SUBJECT: Coastside Design Review Permit and Grading Permit
The Alameda, El Granada
APN 047-127-520; County File No. PLN 2018-00454

Staff has reviewed your application for Design Review and staff-level Grading Permits to allow construction of a new 1,917 sq. ft. one-story single family residence with a 493 sq. ft. detached 2-car garage and a 749 sq. ft. second unit on a 6,000 sq. ft. legal parcel (legality confirmed via merger: PLN2017-00235), including 655 cubic yards of cut and no fill. No significant trees are proposed for removal. The second dwelling unit is a ministerial project that did not require discretionary review or approval.

COHN RESIDENCE

SHEET NO.
A-2

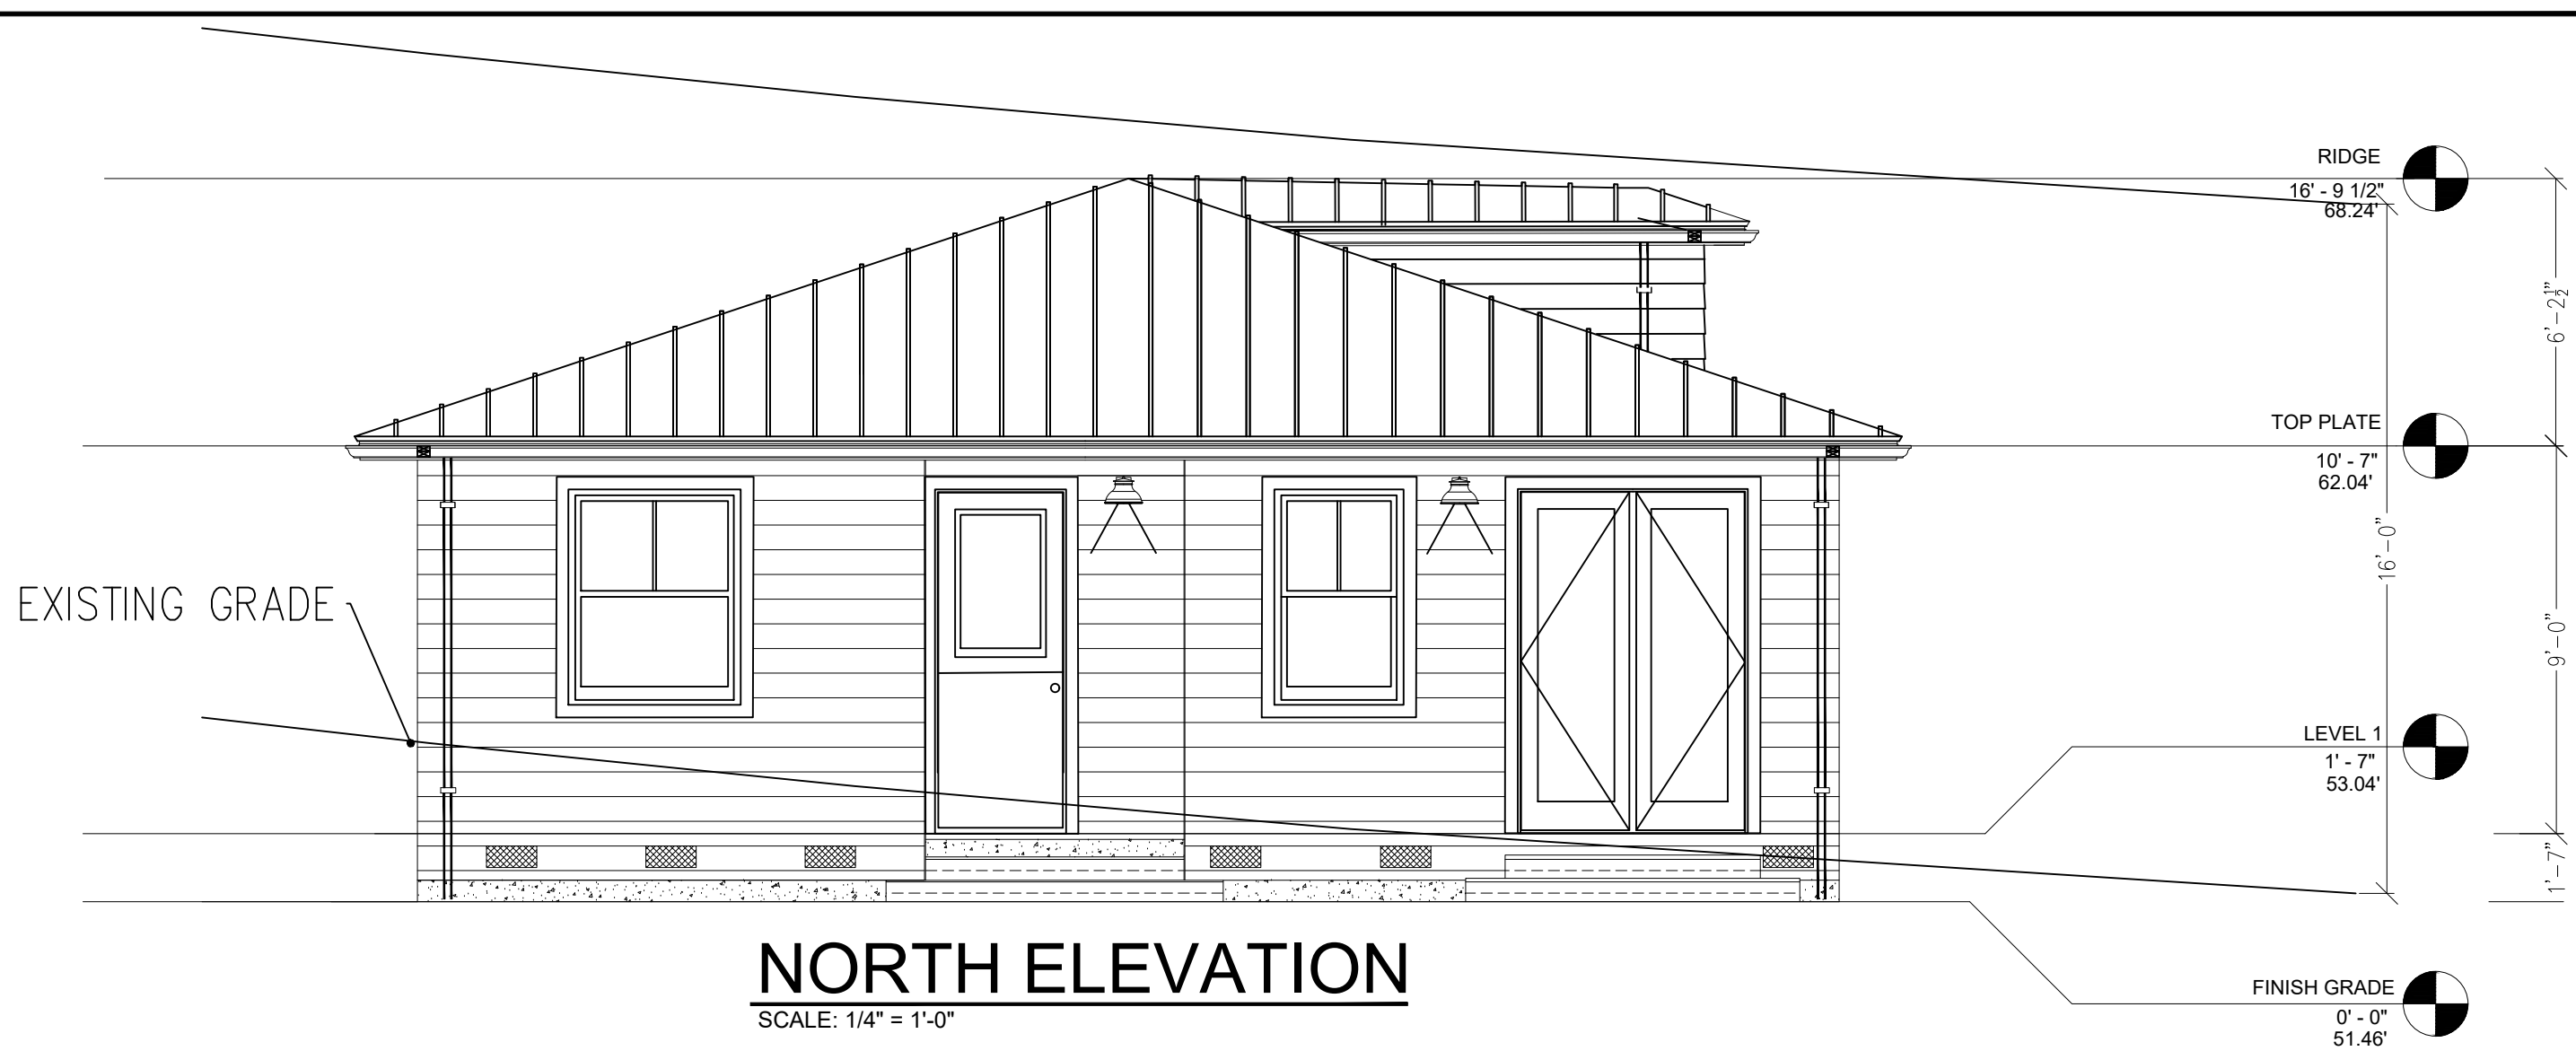
- d. Replace the white redwood fence with a post-and-rail fence with wire.
 - e. On the west elevation, shift the three kitchen windows to be centered with the kitchen island to avoid being out of alignment with the ceiling transition and dormer. Revise the proposed picture window to be two picture windows centered under two transom windows in the dormer. For optimal views, consider an additional picture window of same proportion closer to the front of home. Add divided lites to these windows at the upper part of the panes to mimic the other proposed windows.

SHEET TITLE:
LANDSCAPE PLAN

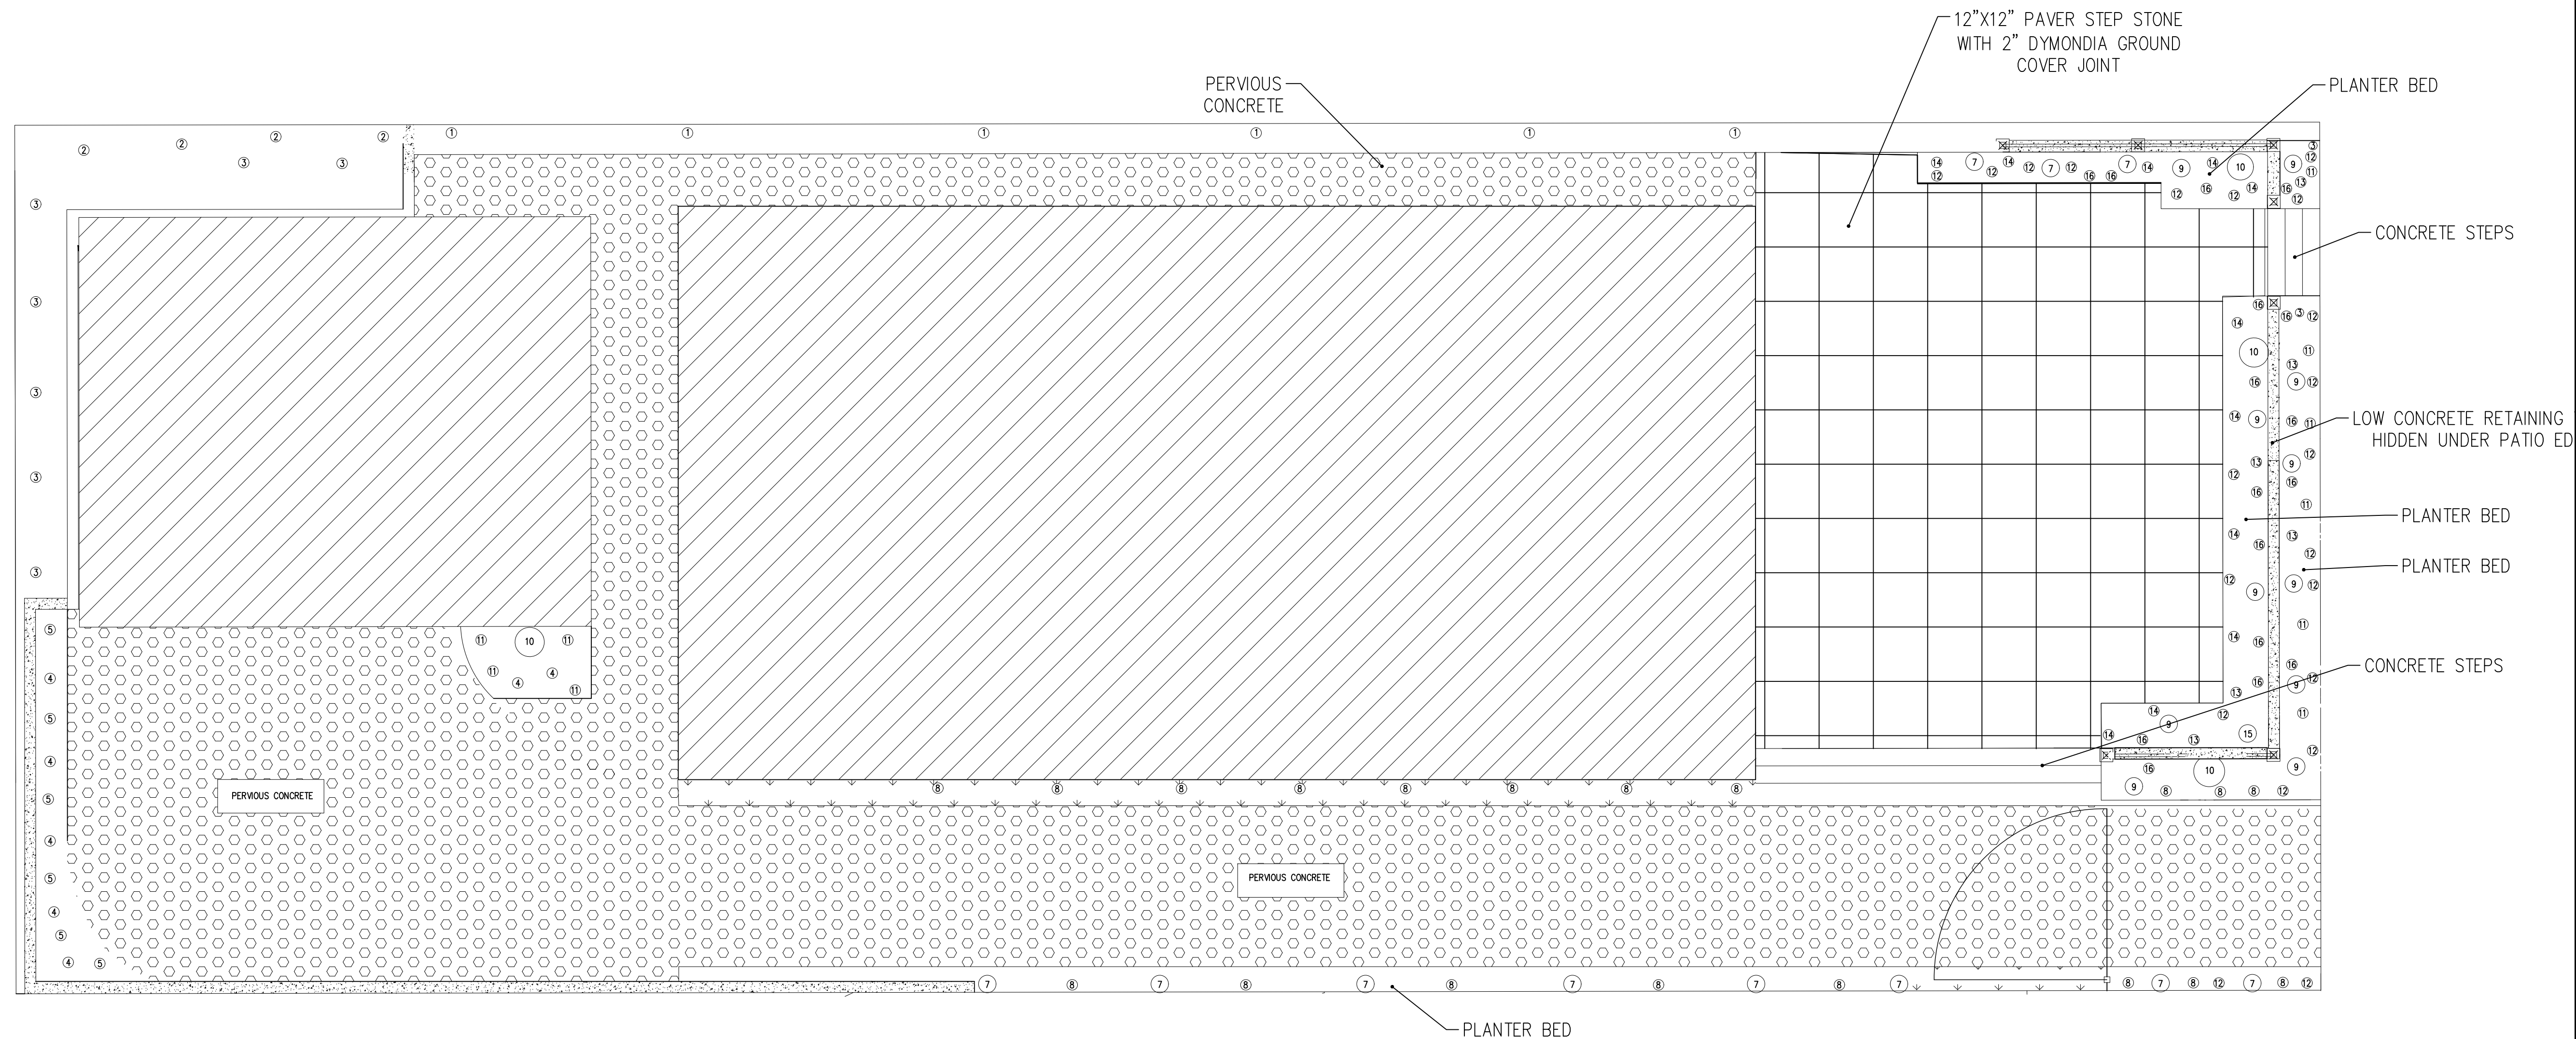
- a. Add more perimeter planting to the landscape plan.
 - b. Revise the landscape plan to account for the retention basin.
 - c. In the landscape plan and the civil plan, coordinate the details for steps and the retaining wall in the front yard.
